NSL- 7810

ADMINISTRATIVE APPLICATION CHECKLIST

Applicant: DJR Operating, LLC	OGRID Number: 371838
Well Name: Candado #2	API: 30-039-06552
Pool: Blanco P.C. South Prorated	Pool Code: 72439

**REQUEST FOR ADMINISTRATIVE APPROVAL FOR
NON-STANDARD LOCATION (EXISTING)
FOR
DJR OPERATING, LLC
CANDADO #2 (API 30-039-06552)
BLANCO P.C. SOUTH PRORATED POOL (72439)
583' FSL, 1262' FEL,
SECTION 9 (P), TOWNSHIP 26 NORTH, RANGE 7 WEST, N.M.P.M.
LAT = 36.4951745 NORTH
LONG = 107.5758667 WEST
NAD 83
RIO ARRIBA COUNTY, NEW MEXICO**

DJR Operating, LLC
Existing Candado #002 Well Location
and
Adjacent Well Spacing Unit Exhibit
Blanco P.C. South Prorated Pool (72439)
Sections 9, 10, 15 & 16, T26N R7W NMPM
Rio Arriba County, NM

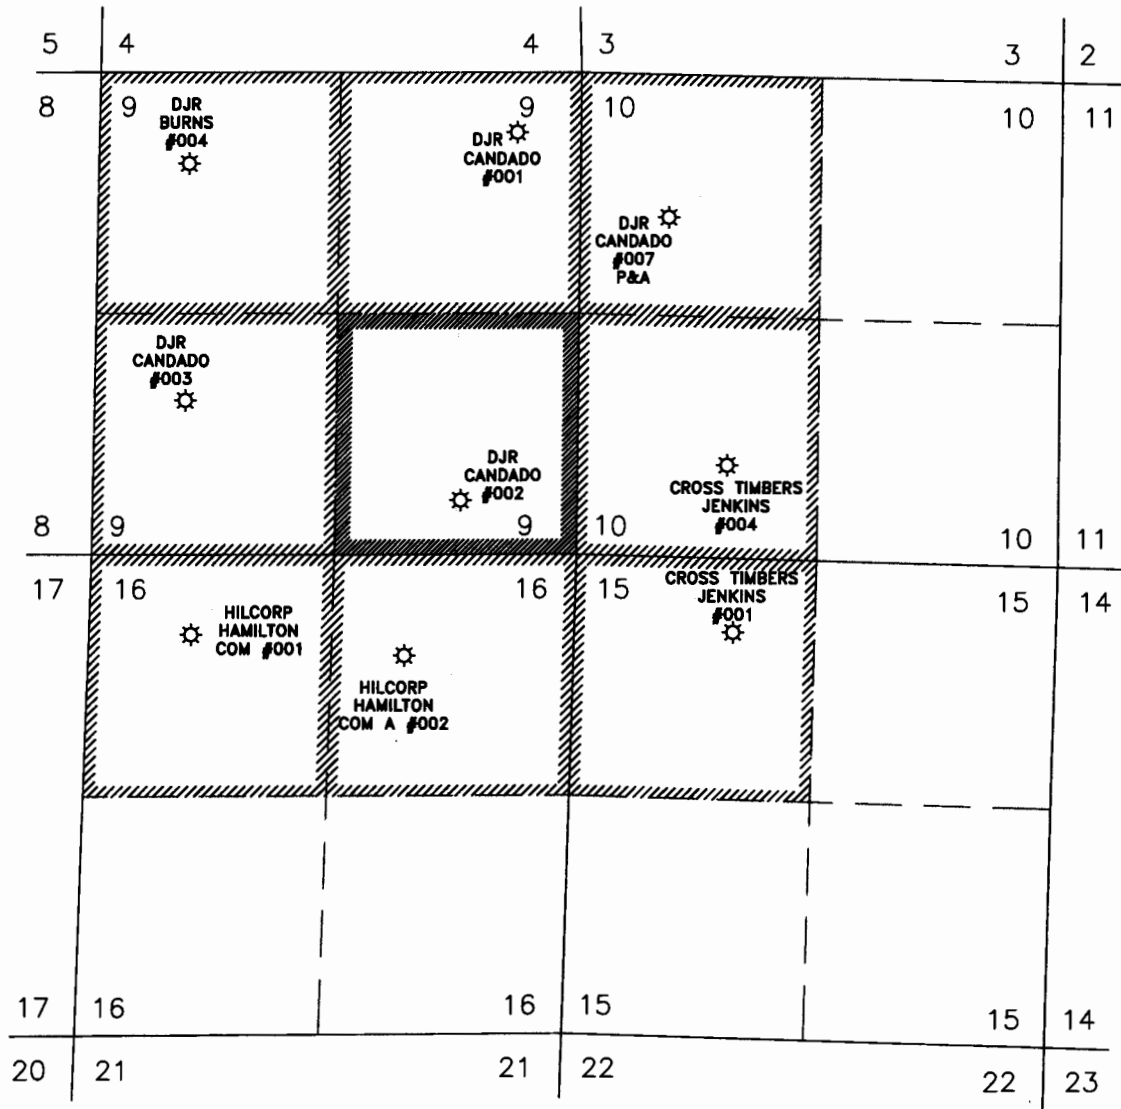
What is the Spacing unit you are adhering to for this well?

Are there affected parties? If so, who are they? Where are they located?

Mr. Lowe-the spacing unit for the Candado #2 is the SE/4 of Sec. 9. It should be noted on the plat included with the package, showing this spacing unit and the offsetting spacing units.

The encroaching party is Hilcorp, they operate the well in the NE/4 of Sec. 16 to the south. Our Candado well encroaches on this spacing unit.

That is also shown on the plat, along with the narrative I included. They were sent a certified complete copy of the application. That is also included.
